AFFORDABLE HOUSING
DEVELOPMENT SSD-83256463
ARCHITECTURAL DRAWINGS
THE BOULEVARDE
PUNCHBOWL
COLLINS AND TURNER
SEPTEMBER 2025

No	Date	By	Note
B	9/12/2025	DC	For RTS

Project	
Affordable Housing Development SSD-83256463 150 The Boulevard and 34 Dudley Street Punchbowl, NSW

Drawing Title Sightline Analysis

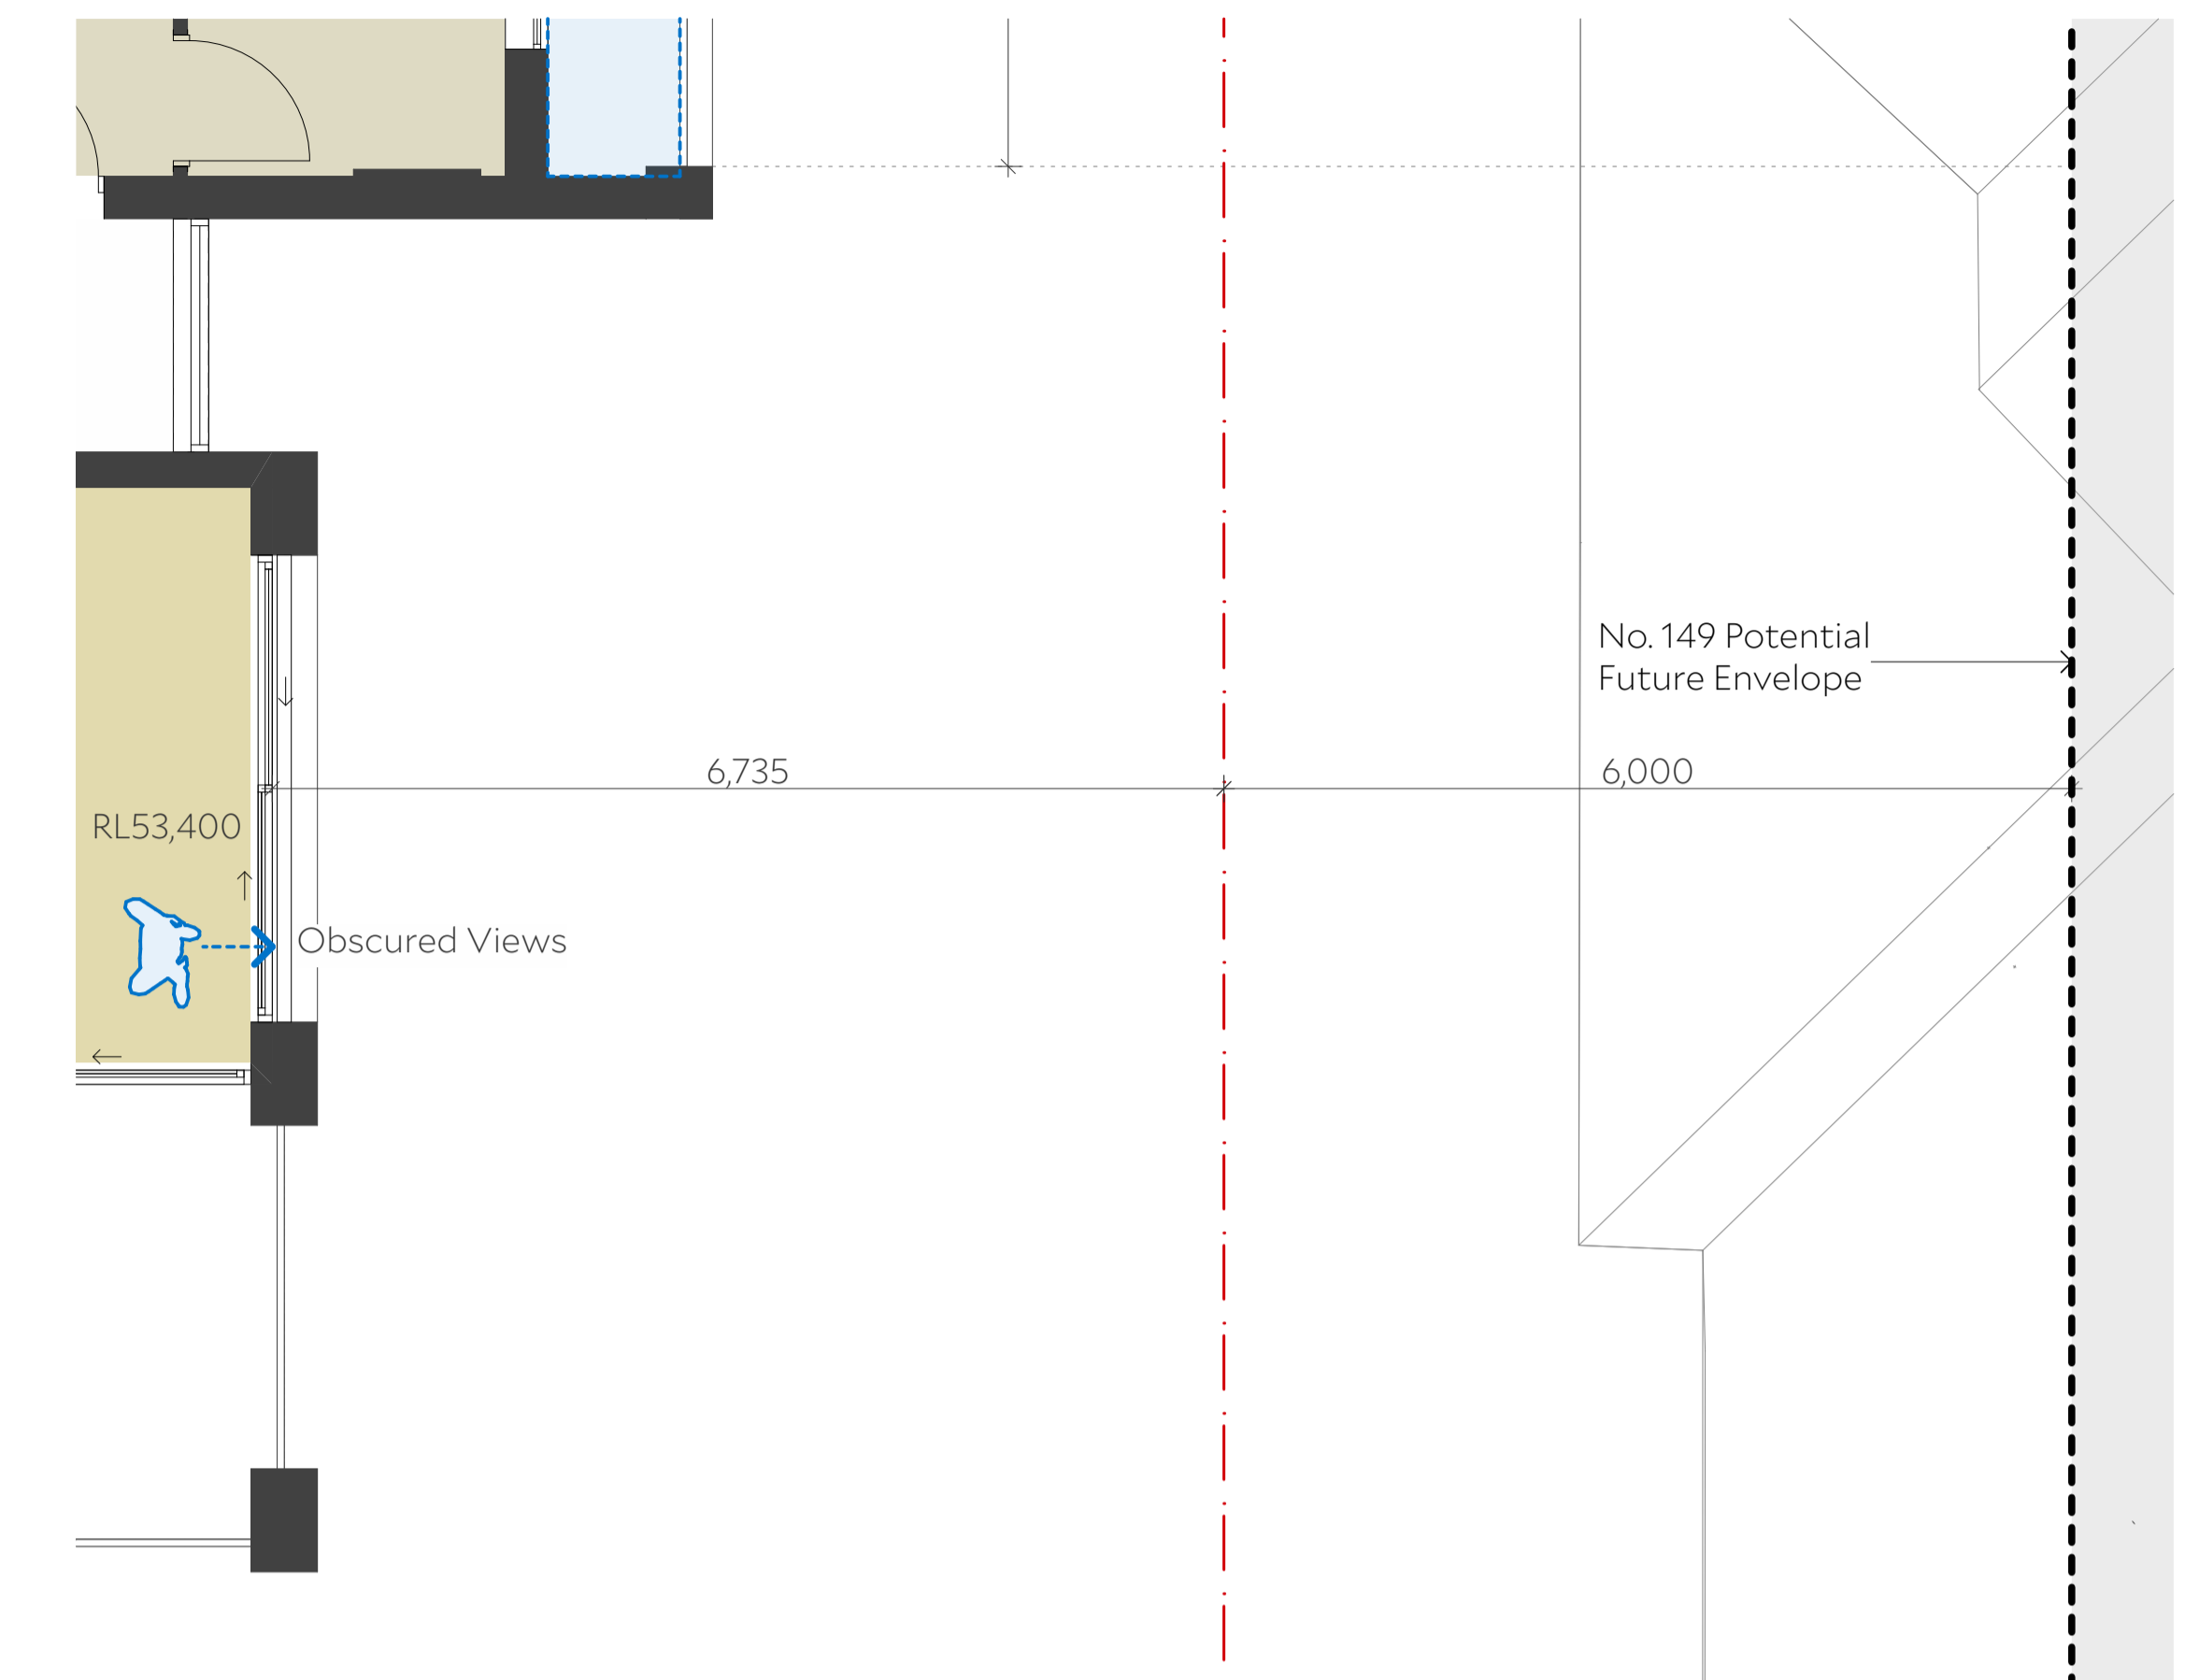
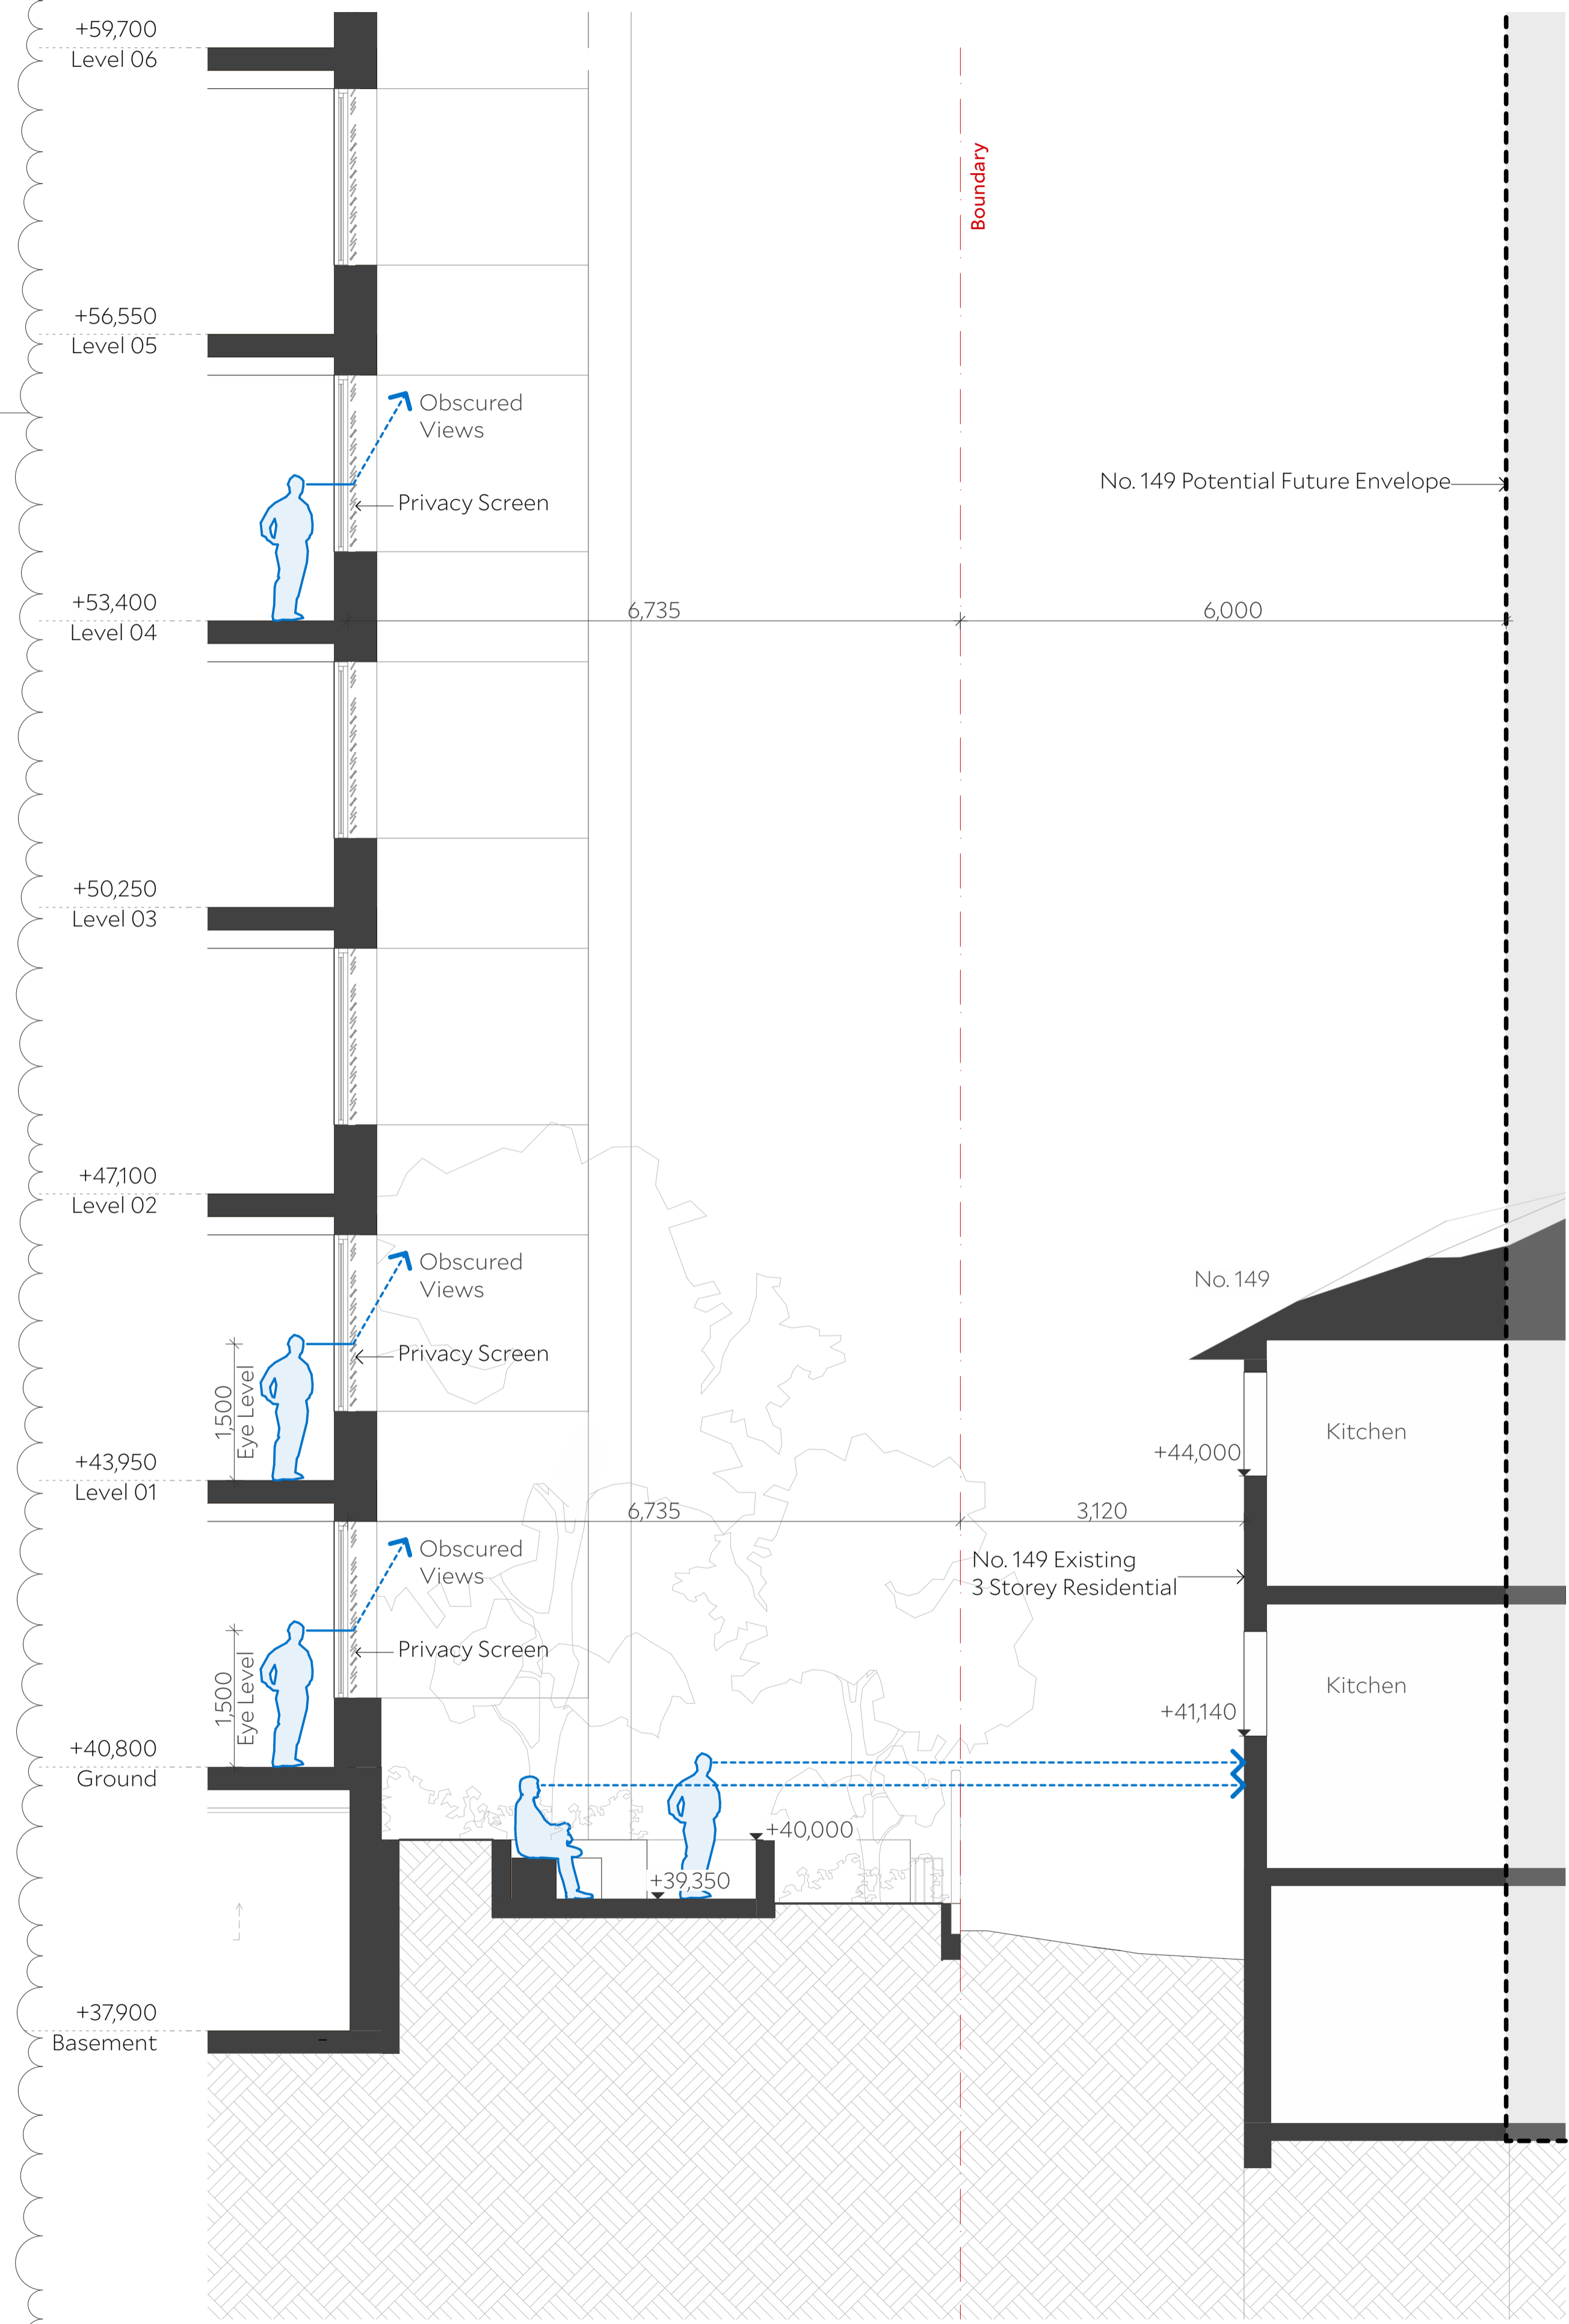
ID	Name
14	Horizontal privacy screens added Refer to RTS Item CB-UD2.1
